CONVAIR

COMMERCIAL CHANGE PROPOSAL

SPEC NO.: ZD- 22-002

MODEL: 22-1 (Convair "880")

Page 126A, FIGURE 3.20-1 AIR CONDITIONING AND PRESSURIZATION SYSTEM:

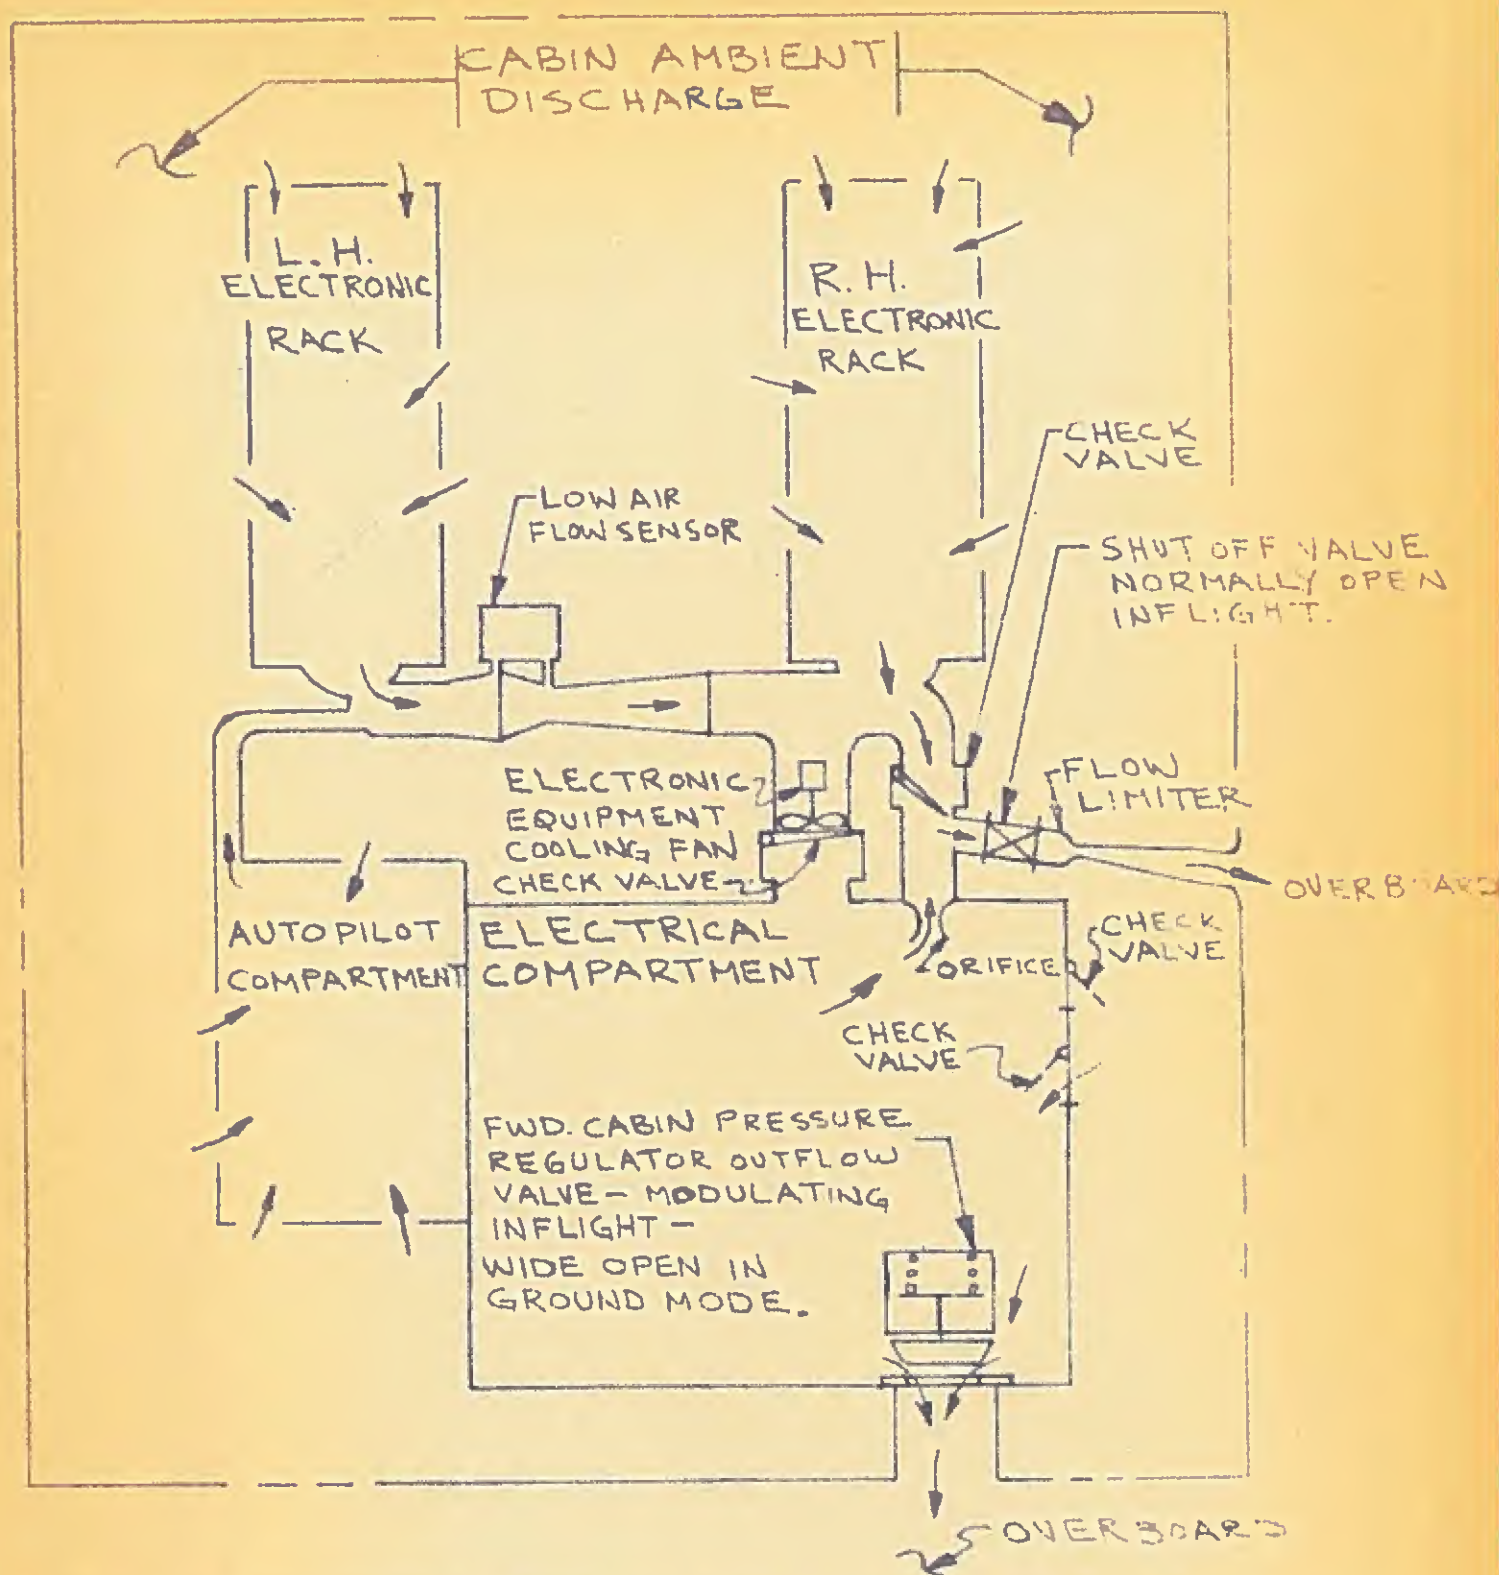
Above illustration to be revised to show the effects of this proposal.

Enclosure: (A) One copy Convair Sketch - AIRFLOW PATTERN SHOWN FOR NORMAL INFLIGHT MODE (For information only)

Enclosure: (B) One copy of Convair Sketch - ELECTRICAL EQUIPT COOLING VALVE LOCATION (For information only)

Page 61A, FIGURE 3.14--1 PILOT'S AND COPILOT'S INSTRUMENT PANELS:

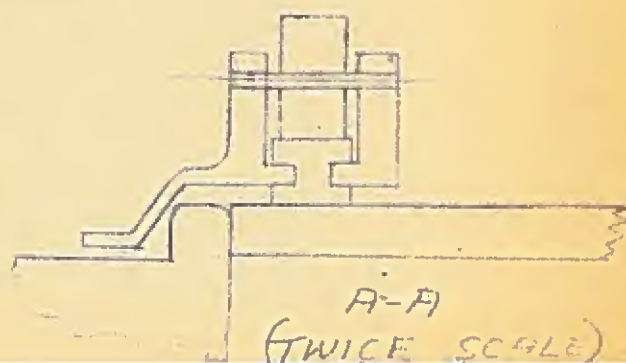
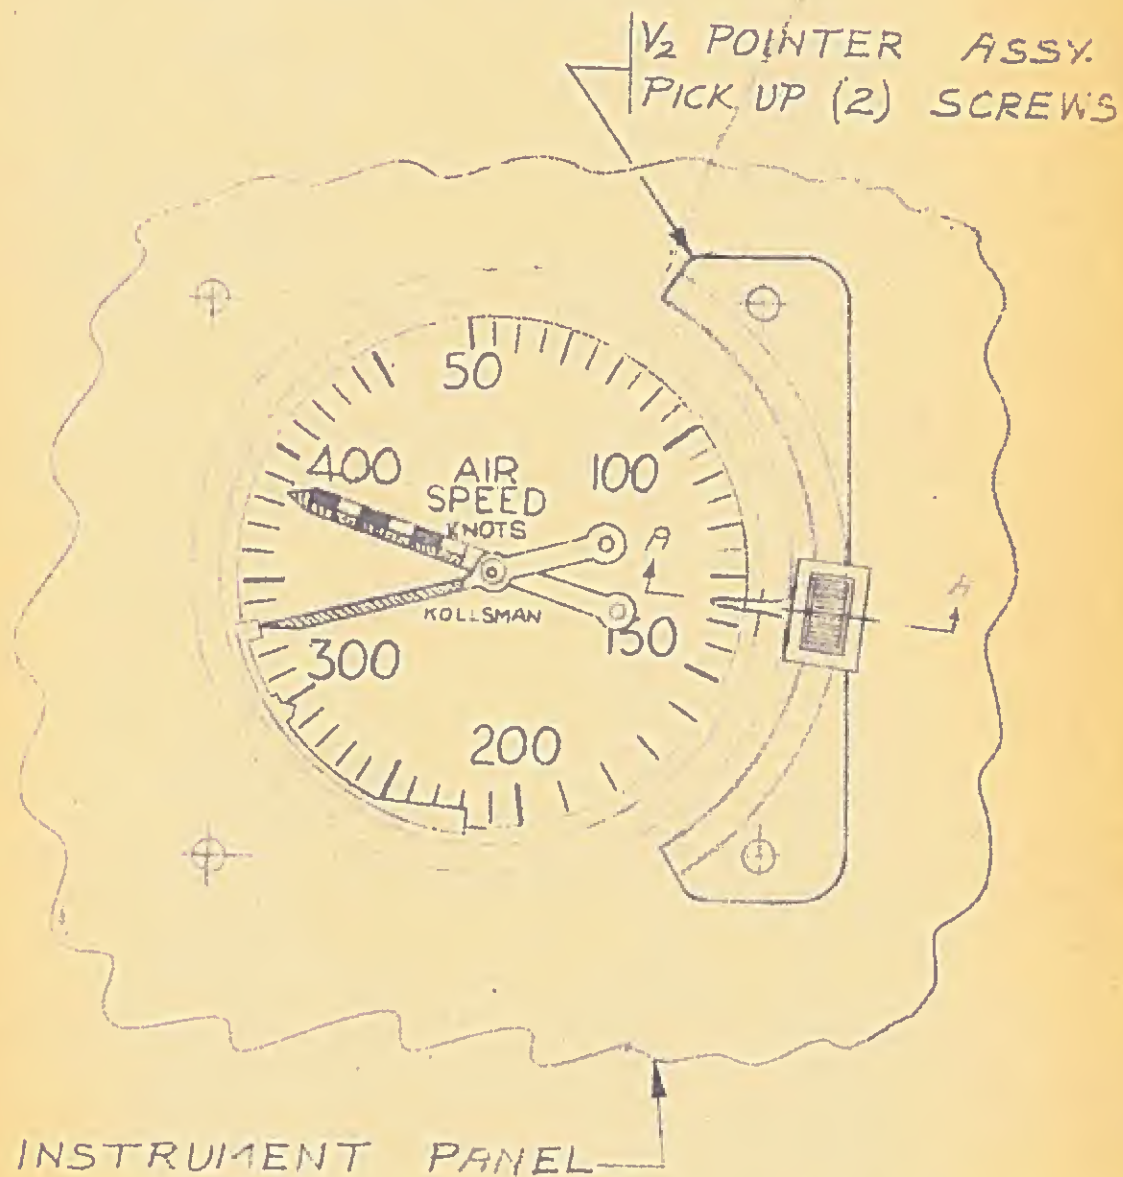
Revise above illustration by adding settable V_2 index pointer for airspeed indicator.

"2 Settable V_2 Index Pointer for
Airspeed Indicator (P/N to be supplied)"

Enclosure: (A) One copy Page 54A - ENGINE STARTING SYSTEM (Revised).

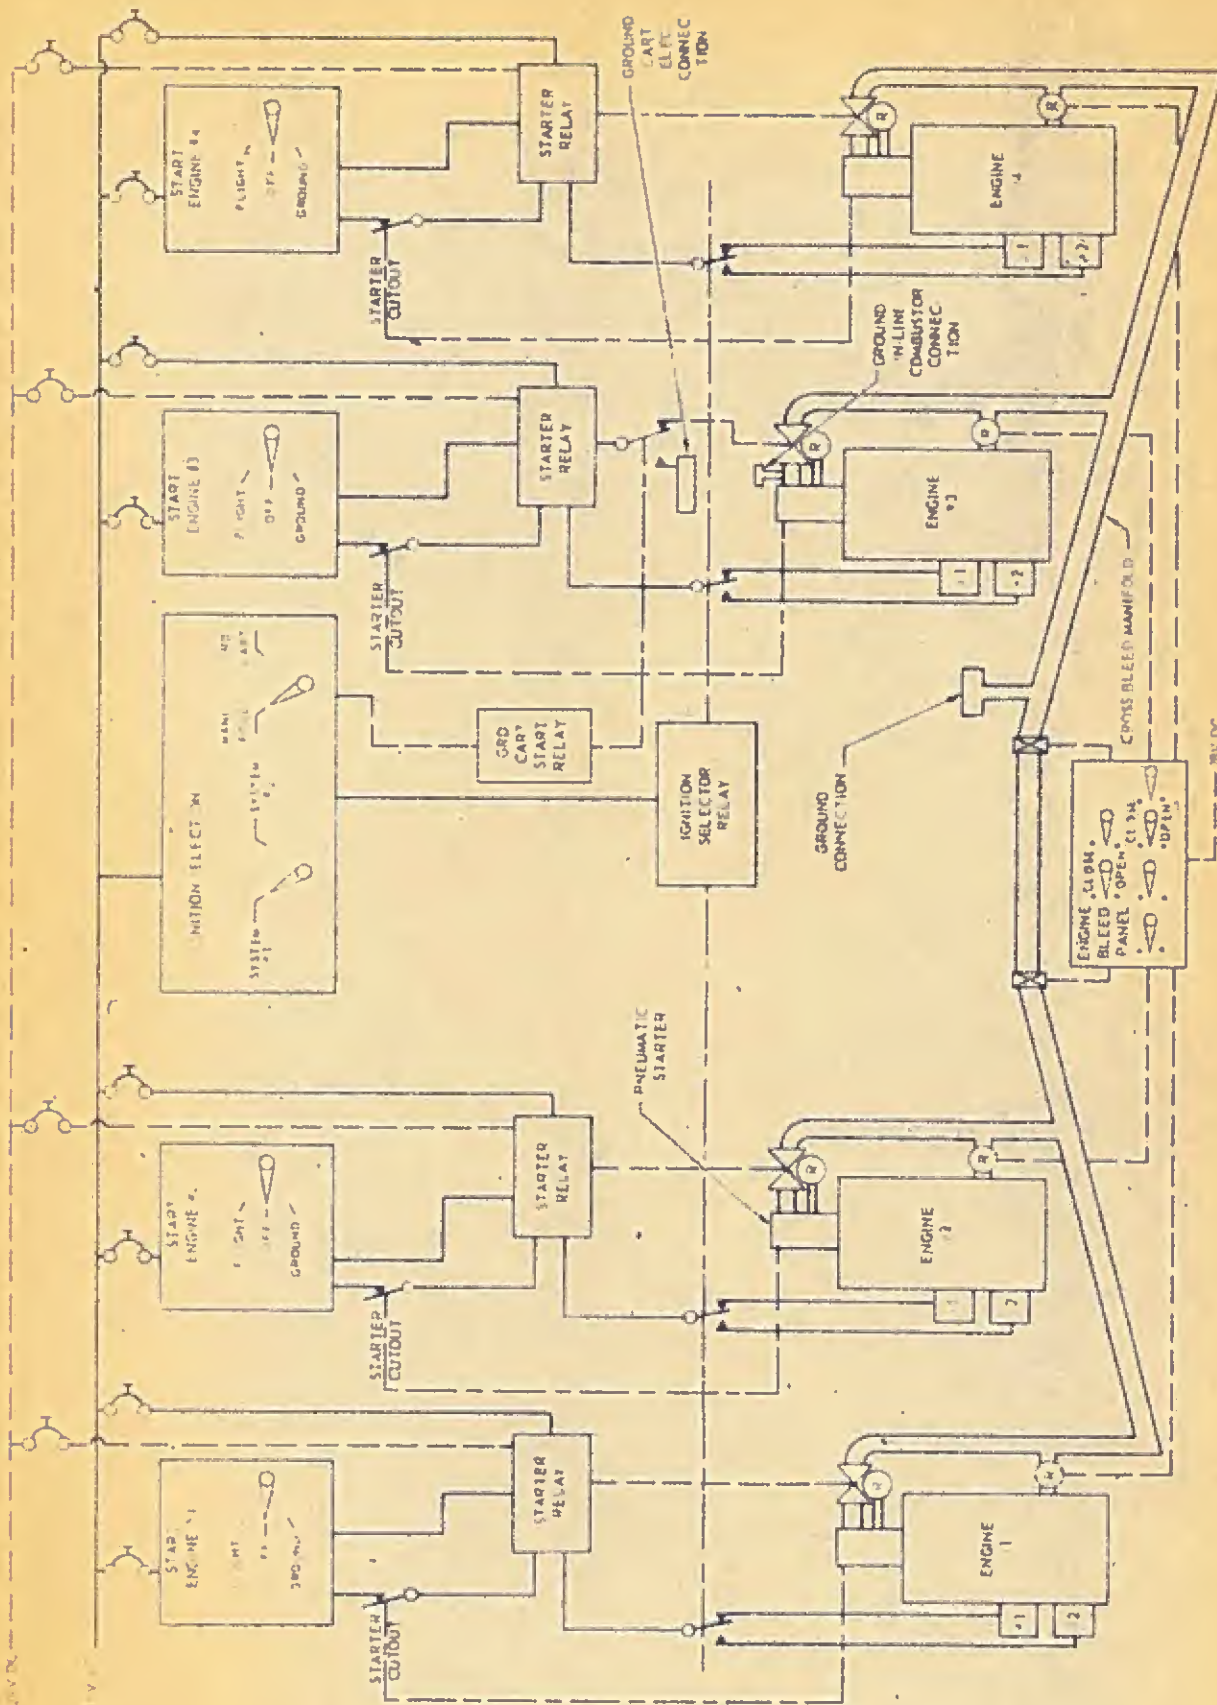
Delete the entire paragraph, including paragraph number and title.

FIGURE 3.14-6

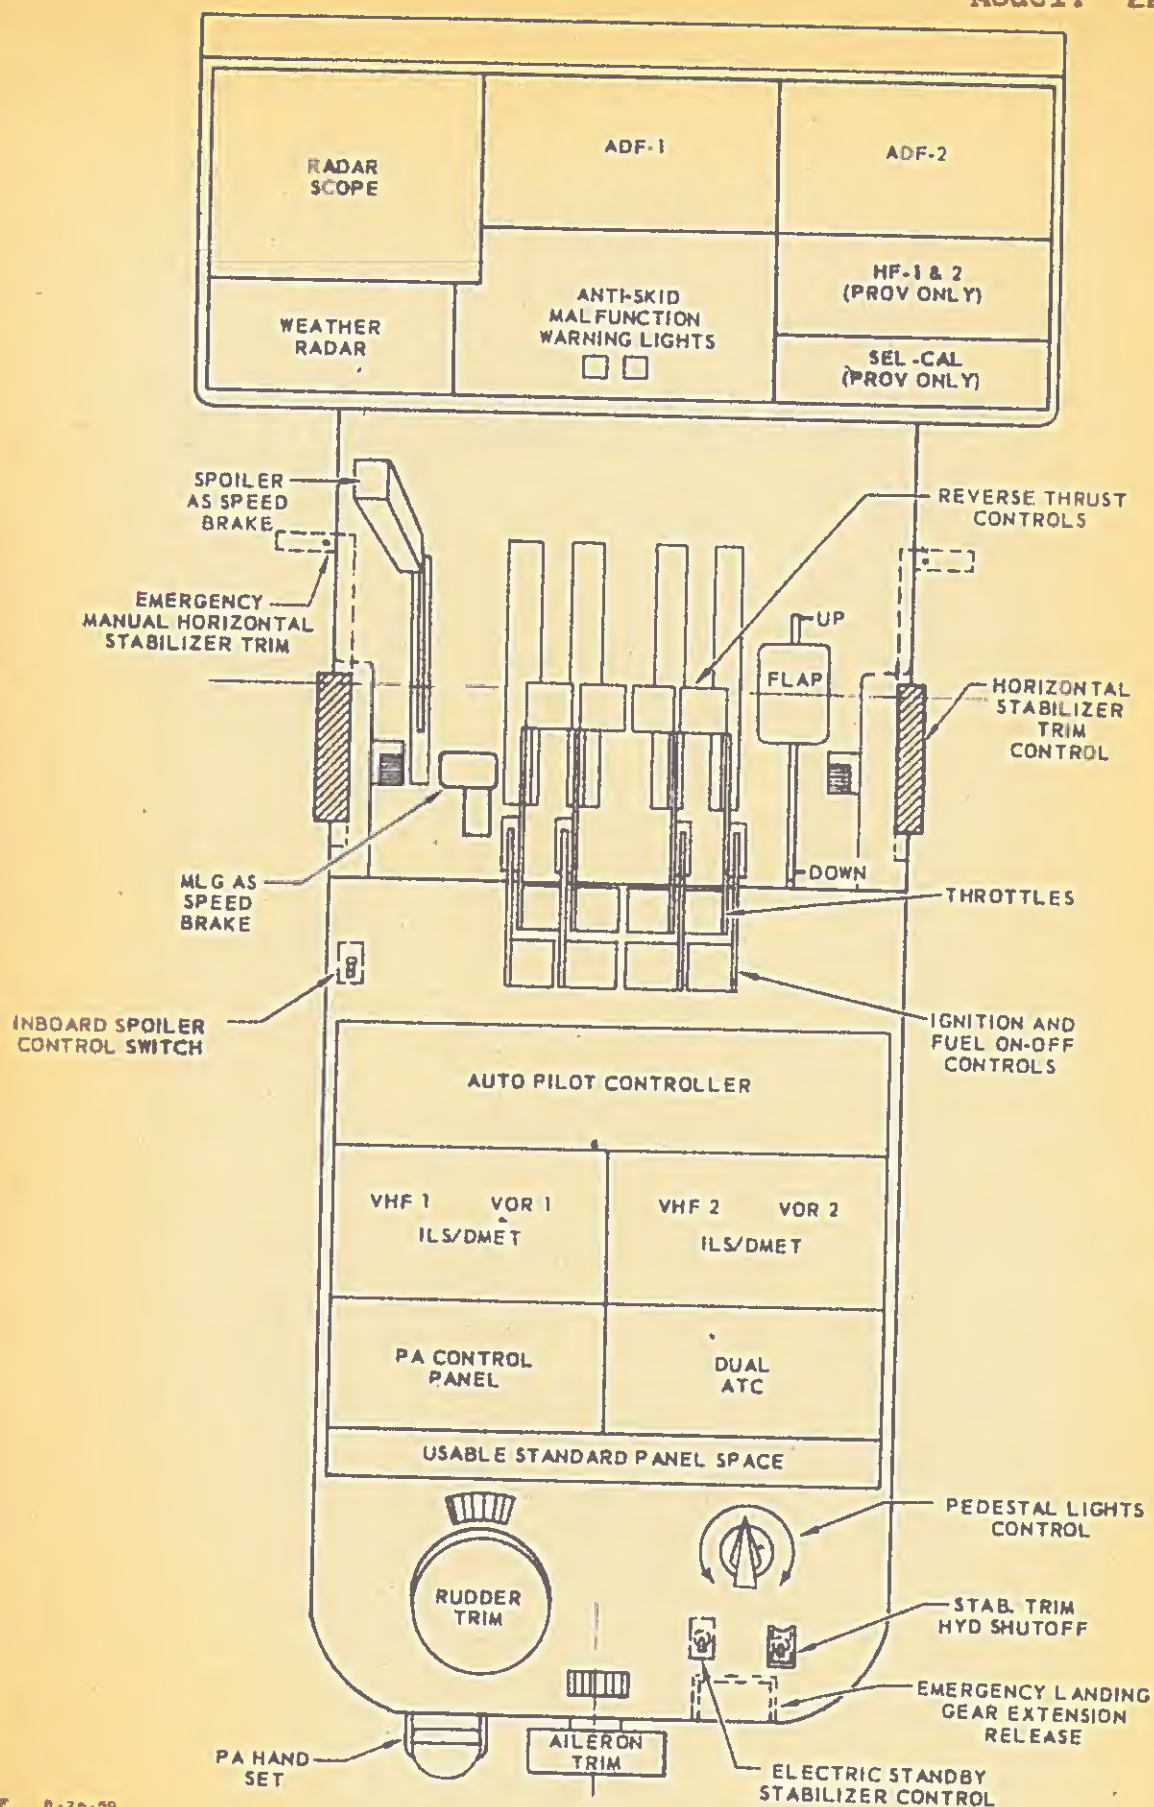
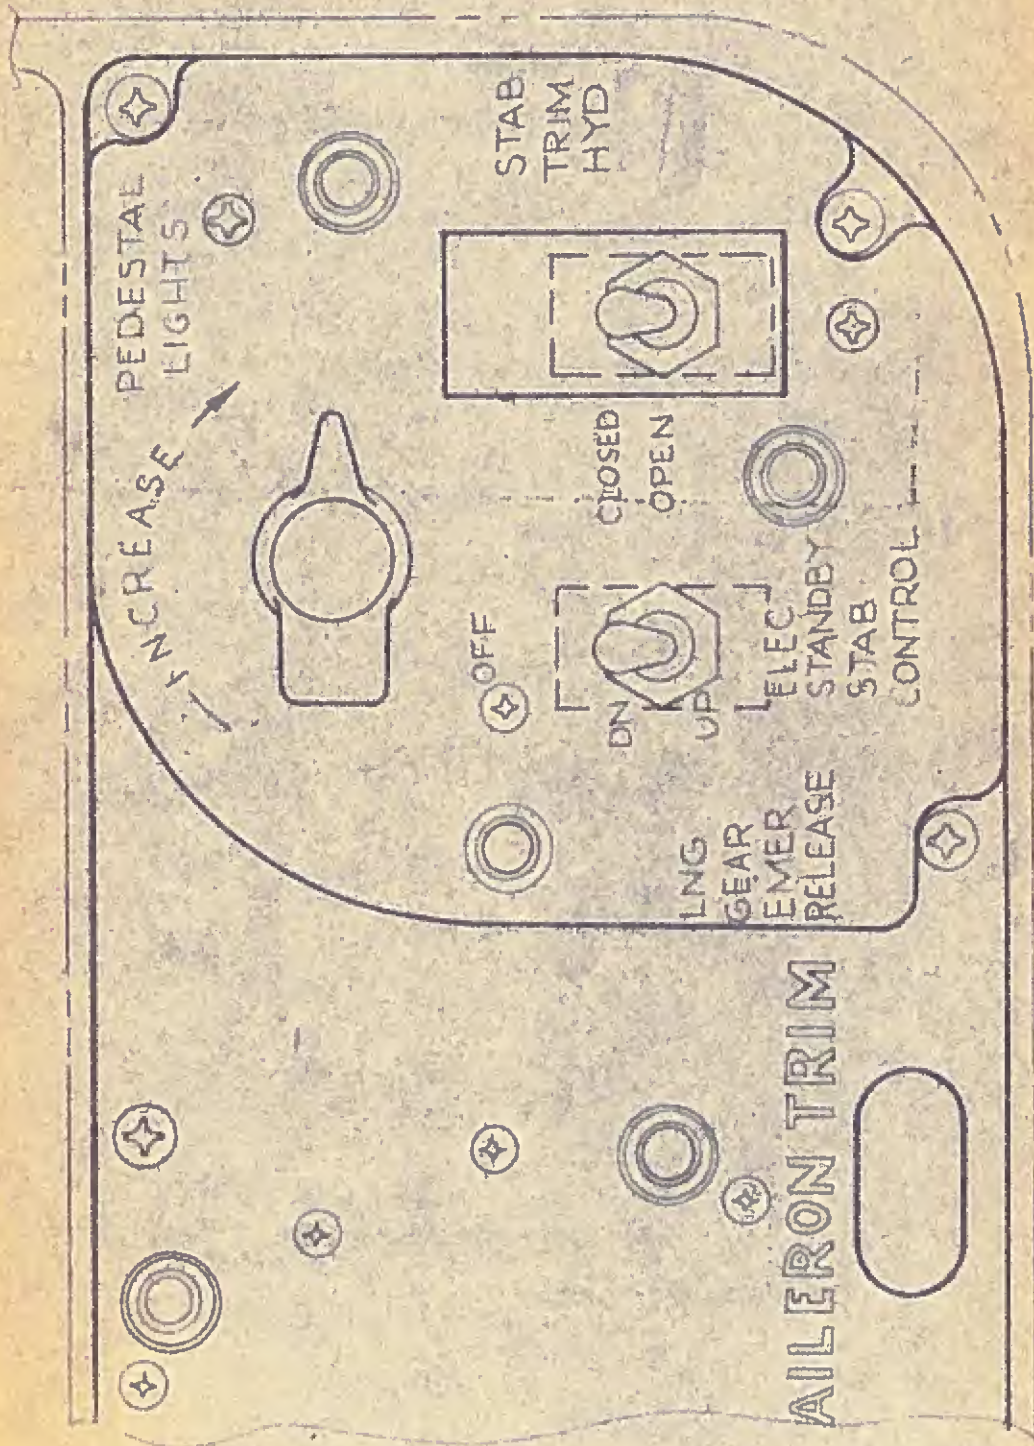
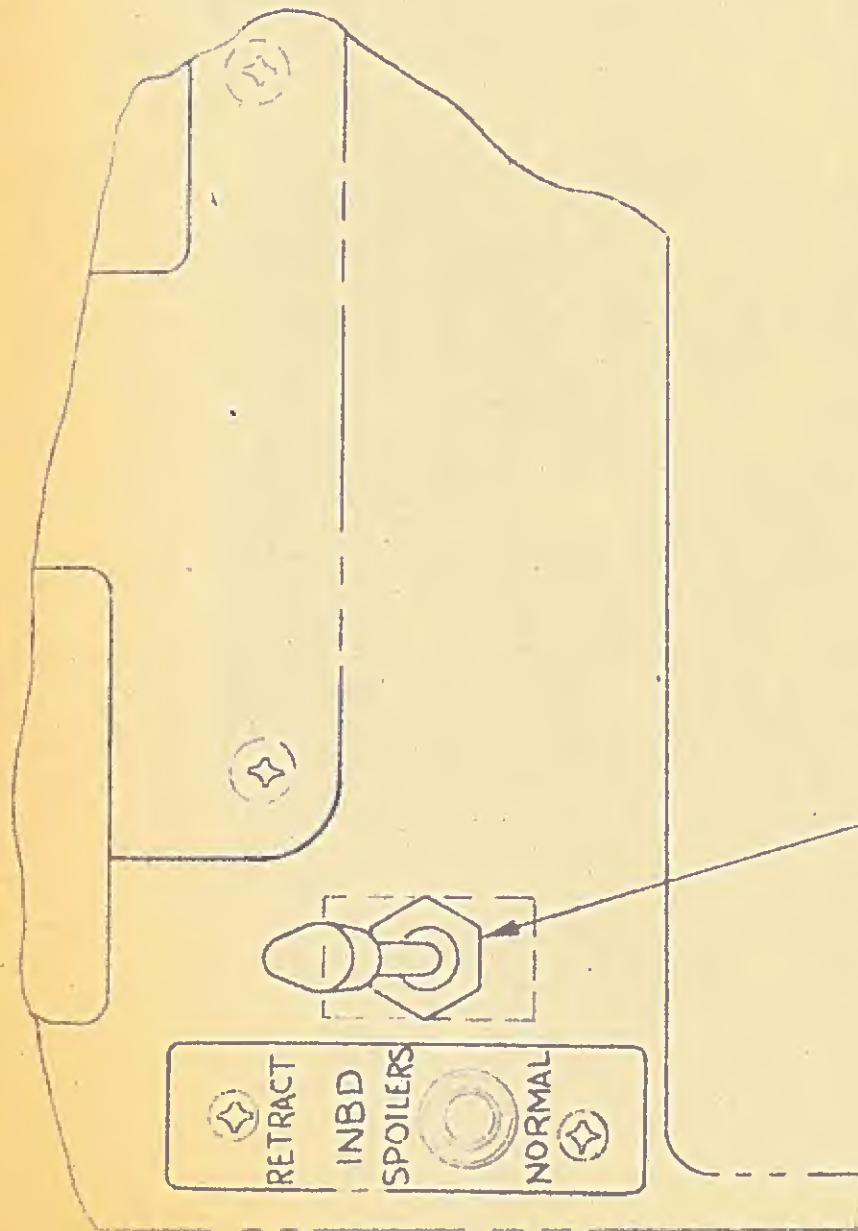
Page 104A, Figure 3.17-1 PILOT'S AND COPILOT'S PEDESTAL:

- Enclosures: (A) One (1) copy of Figure 3.14-6 PILOT'S AND COPILOT'S PEDESTAL
- (B) Convair Sketch showing labeling of Electric Standby Stabilizer Control and Stabilizer Hyd.
(For information only.)
- (C) Convair Sketch showing labeling of Inboard Spoiler Switch (for information only.)
